Venice Neighbors for Responsible Development*

***Opposition to the Planned Construction
on 17, 19,& 21 Jib St.***

**Regarding Proposed Apartment Building Located on 17-21 Jib St. MDR 90292
Case # CPC2025-1561-DB-CU2-MEL SPPC-HCA**

**Elevations
drawn to
scale**

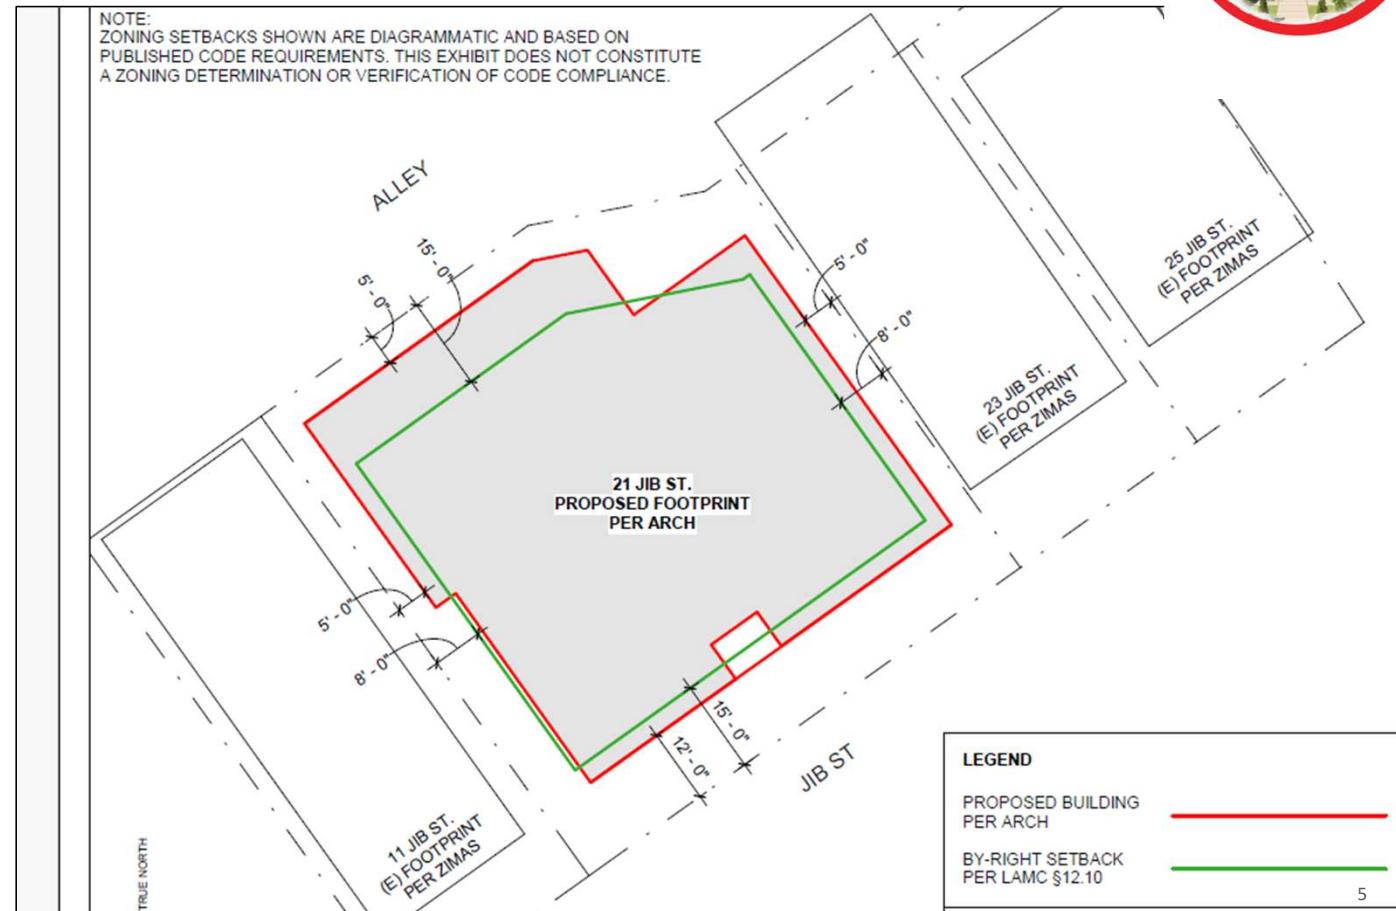
At 59 feet the building would tower over the neighboring buildings - almost 20 feet **higher**.

The building's height, breadth & massivity would

- Block sunlight
- Diminish natural airflow
- Cause significant noise
